SUBJECT: REPLY TO A NOTICE OF NONCONFORMANCE - 99901350/2003-201

Item 99901350/2003-201-01

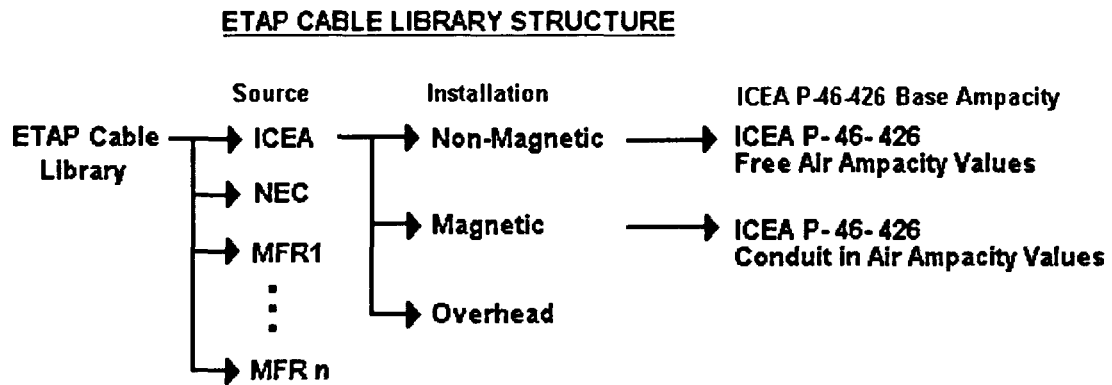
NRC: “As of January 8, 2003, OTI failed to ensure that its ETAP-PS library base Ampacity values for “free air” licensee applications was the same as that specified in the Insulated Cable Engineers Association (ICEA) Standard P-46-426 for free air values.”

OTI: The ICEA cable Base Ampacity values for “free air” applications were re-evaluated against the data provided in the Insulated Cable Engineers Association ICEA P-46-426. This re-evaluation has confirmed that ETAP library data based on ICEA P-46-426 is correct and no-errors were found.

The structure of the ETAP Cable library is shown in the following figure:

ICEA P-46-426 only extends to free air Base Ampacities for non-magnetically installed cables. Therefore, if the free air Base Ampacities are to be compared against the ETAP library values, then the non-magnetic library subdivision must be selected. The Etap library shows the more conservative conduit in free air Base Ampacities for magnetic installations (trays that provide circulating currents).
